**A57 Link Roads**

**TR010034**

**9.87 Applicant's Comments on Deadline  
10 submissions**

#### 9.87 Applicant's Comments on Deadline 10 submissions

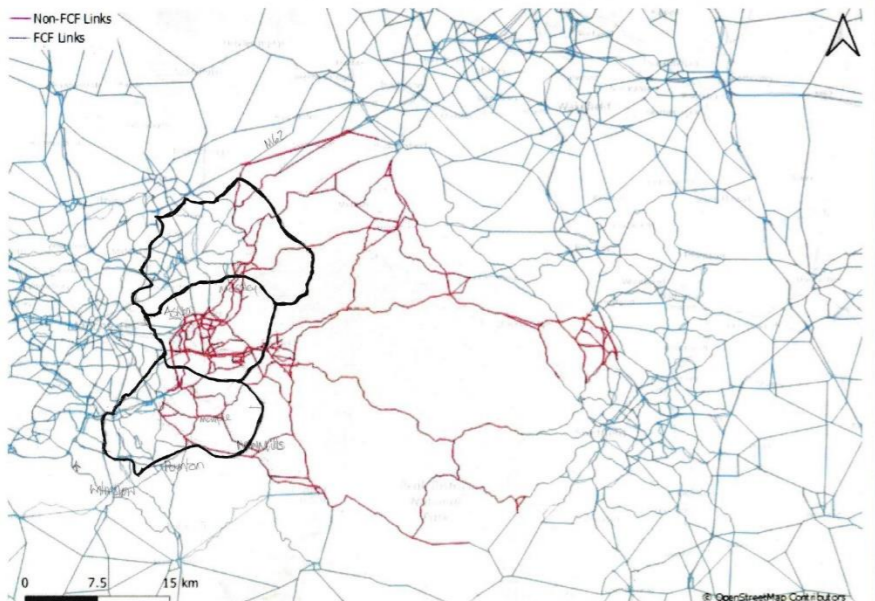
Reference	IP Issue	NH Response
9.87.6	In summary this Select Link Analysis reinforces the need for a full and proper assessment of the impacts of traffic on Glossopdale. More detailed investigation of just one link – Dinting Road – has raised yet more uncertainties about the outputs from the traffic modelling, and the impact of traffic on the environment and people, particularly air pollution. If closer scrutiny of one link throws up such anomalies, what would a full and proper analysis of the whole of Glossopdale reveal?	The Select Link Analysis for Dinting Road (REP9-029) is a more detailed output from the traffic model used to assess the Scheme. It is therefore consistent with all other output from the traffic model and assessment of the Scheme previously submitted into the dDCO Examination. Consequently, it does not raise any uncertainties regarding the traffic modelling outputs.

9.87.7	<p><b>Origin of increased flows on Dinting Road</b></p> <p>The Select Link Analysis<sup>1</sup> shows a mix of local and strategic traffic using Dinting Road in both the modelled DM and DS scenarios in 2025. Without the scheme the longer distance traffic is drawn from a wide area using routes such as the M67 and, to a lesser extent, the A57 Snake Pass and Roe Cross Road.</p> <p>With the scheme the increased traffic flows are attributed to ‘firstly, the introduction of the scheme attracts more trips through the local area due to improved journey times, so it is expected that there will be an increase in flow on this road. Secondly, due to the congestion and delays on Glossop High Street, more trips route via Dinting Road as it presents a viable alternative route for some users of the A57 scheme and reflects the increase in traffic forecast to use the A57 Snake Pass’.</p> <p>This refutes DCC’s belief ‘that the changes in traffic flow on the local roads in Glossop arise from... changes in the travel behaviour of local people who currently reside in the town,’ and not ‘from people from elsewhere deciding to descend on Glossop purely and simply as a consequence of the scheme’ [REP8-023; REP4-010]. According to NH, increased flows on Dinting Road reflect forecast increased traffic on the Snake Pass. Thus contrary to the Derbyshire Local Transport Plan, the scheme is increasing traffic, and on residential streets where as Steve Bagshaw has shown traffic calming has been pursued [REP9-051].</p>	No response required as issue raised is for DCC.
